TOWN OF KITTERY

ITEM 2—5 Whipple Road—Major Site Plan — Final Review

OVERALL SITE PLAN
 MAINE MEAT BUTCHER & RESTAURANT
 5 WHIPPLE ROAD, KITTEERY, MAINE

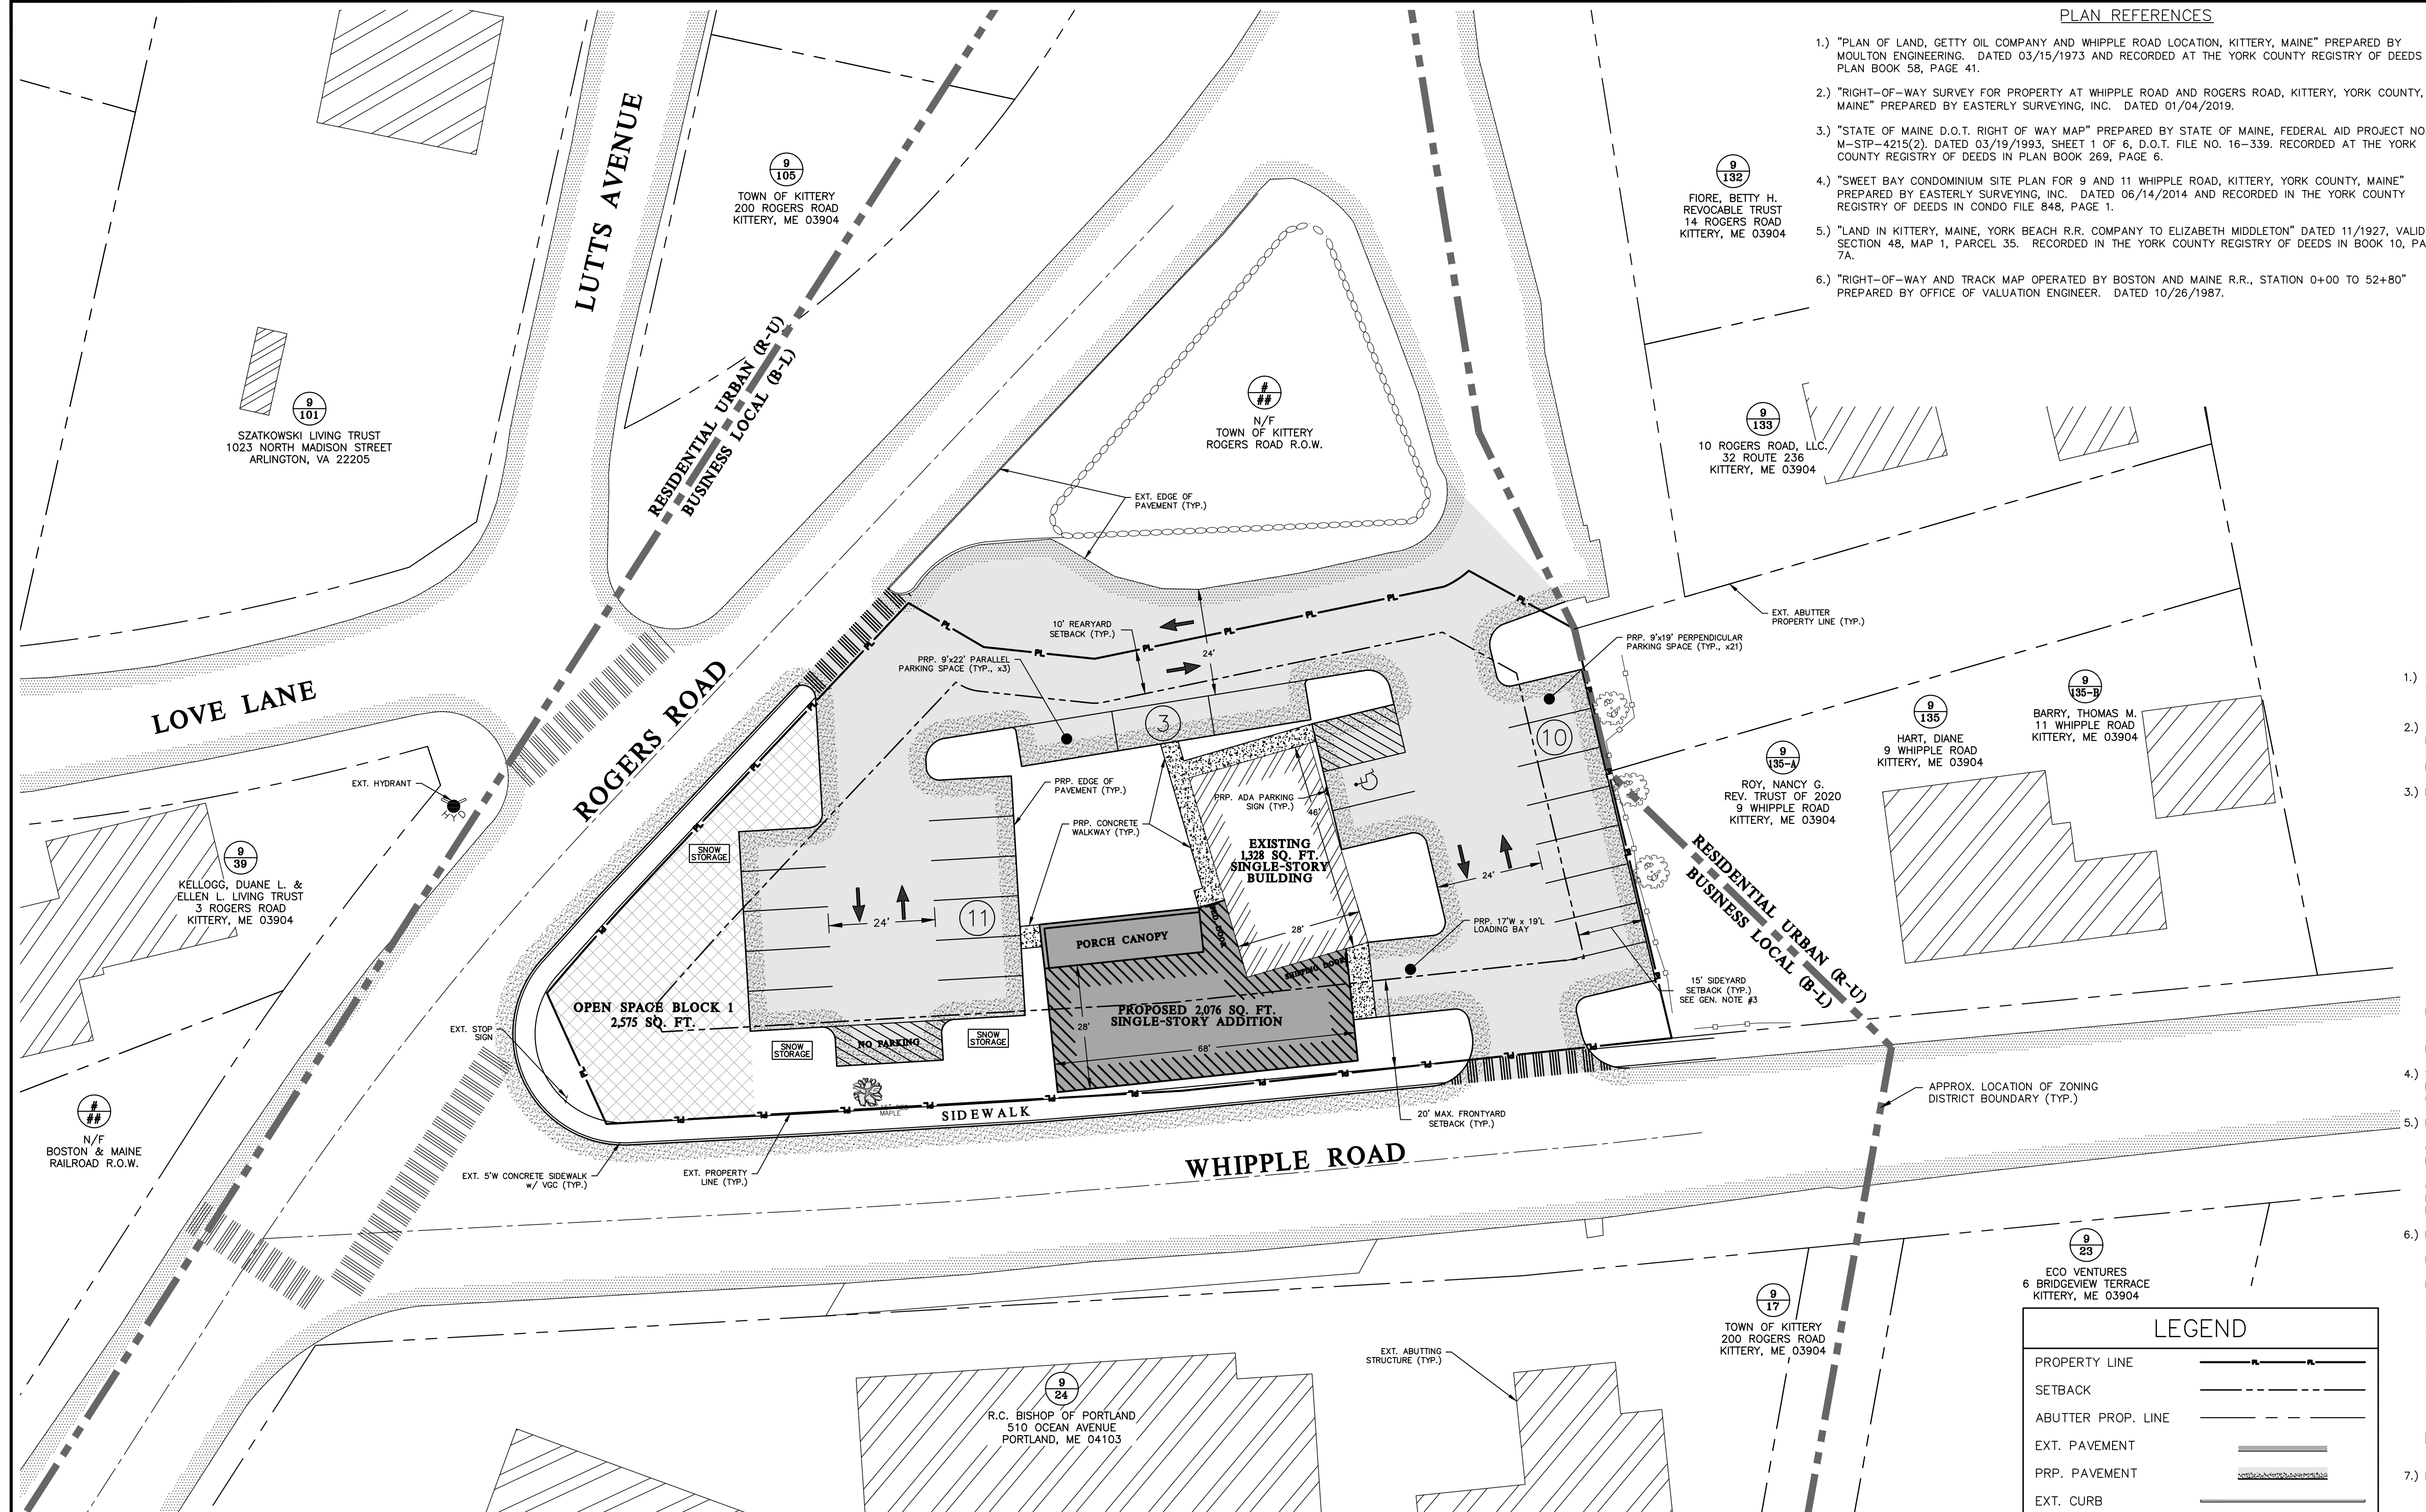
- A “Waivers Requested” notes package has been added to Sheet #1 (Overall Site Plan) which includes all requests discussed at the March 14th Planning Board meeting:

- On-Site Stormwater Management reduction pursuant to §16.4.17.D.(1).(l)&(m)
- A “Conditions of Approval” notes package has been added to Sheet #1 which specifies the intended timeline of conveyance execution, recording, and submission of a stamped boundary survey relative to Planning Board application approval.

- General Note #3 on Sheet #1 has been updated to reflect the provided tree plantings for the proposed development, as well as the proposed frontyard setback and building height measurements to demonstrate compliance.

- The entire Plan Set has been revised to show the removal of one parking space; the northwestern-most space from the western proposed lot and the closest point of impervious to Rogers Road. General Notes #6 & #7 on Sheet #1 have been updated to reflect the new parking total (24 spaces required, 24 proposed) and impervious coverage calculation for the development. The total impervious cover is now beneath the 70% threshold which enables the stormwater management waiver request, and the parking space chosen for removal allows the vegetated landscape planter strip waiver request to be for a more reasonable reduced depth. The Applicant humbly requests the Planning Board continue to support these waiver requests.

- General Note #8 on Sheet #1 has been revised to depict the new open space calculation for the development. With the removed parking space summarized above, this area has been incorporated into the adjacent proposed open space block.

- General Note #14 on Sheet #1 has been added to declare the development's policy on snow storage. Locations have been depicted at select locations and the Overall Landscape Plan has been designed to have perennials in designated snow storage locations to allow for winter-season stockpiling to occur.

- Sheets #1 & #3 have been revised to include Traffic Flow Arrows as requested. Legends on both sheets have also been updated to reflect these additions.

- Sheet #1 has been revised to include the dimensions of the proposed loading bay; 17' in width by 19' in depth.
- Sheet #3 has been revised to include the required landscaping calculations demonstrated in the new Sheet #5 summarized above and to demonstrate compliance with §16.7.11.F.(4).(g).

- Sheet #1 has been revised to differentiate the typical measurements of proposed perpendicular and parallel parking spaces. All relevant callouts have been updated to reflect the appropriate number of perpendicular spaces (21) and parallel spaces (3) covered by these dimensional standards.

- Sheet #1 has been revised to include typical parking space dimensions for both proposed parking space configurations. Additionally, aisle width dimensions have also been added to demonstrate the capacity for two-way circulation throughout the site.

- General Note #10 on Sheet #1 has been revised to reflect the appropriate utility district information.
- Sheet #1 has been revised to depict the existing 15" red maple along the Whipple Road frontage that shall be retained through the proposed development.

- Sheets #1 & #3 have been revised to include handicap parking signage at the designated parking space.
- Sheet #1 has been revised to include the nearby existing fire hydrant referenced in General Note #12.

TAX MAP 9, LOT 134
 EXISTING CONDITIONS PLAN
 MAINE MEAT BUTCHER & RESTAURANT
 5 WHIPPLE ROAD, KITTERY, MAINE

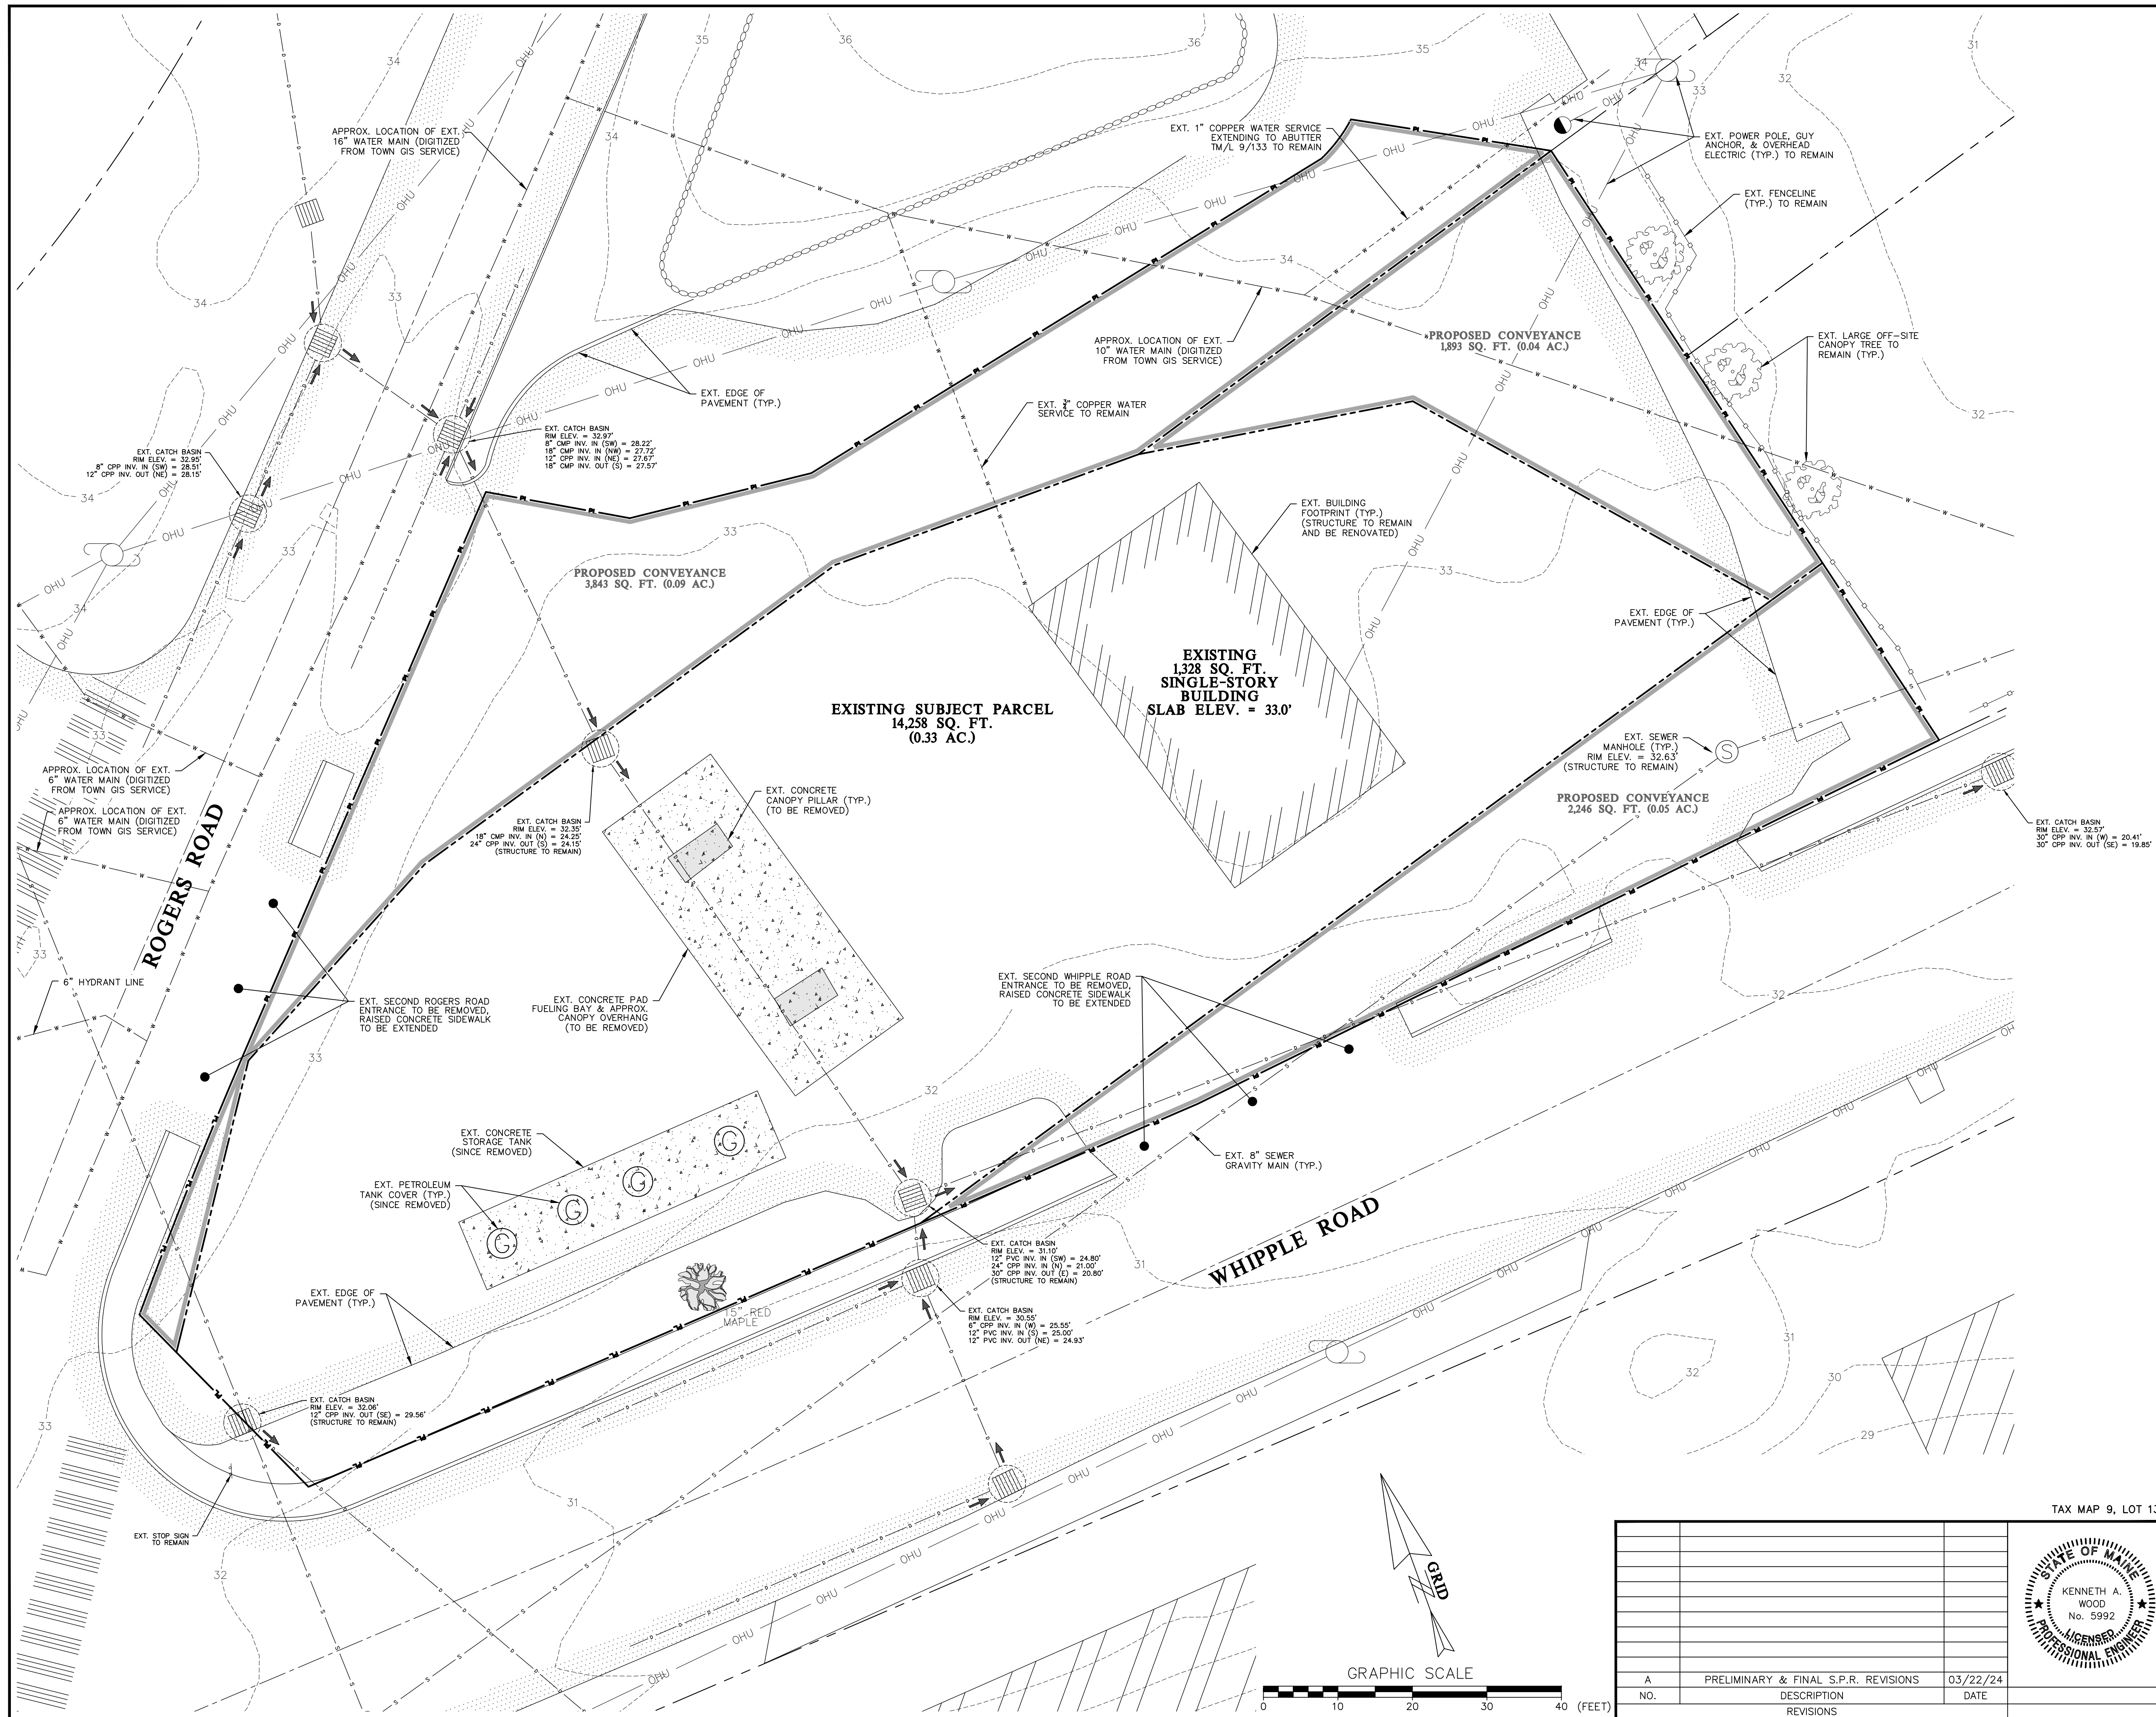
- Sheet #2 (Existing Conditions Plan) has been revised to also serve as the application's Demolition Plan. Existing callouts have been updated and new callouts have been added to declare which existing entities are to remain, be removed, or have already been removed through environmental remediation efforts.
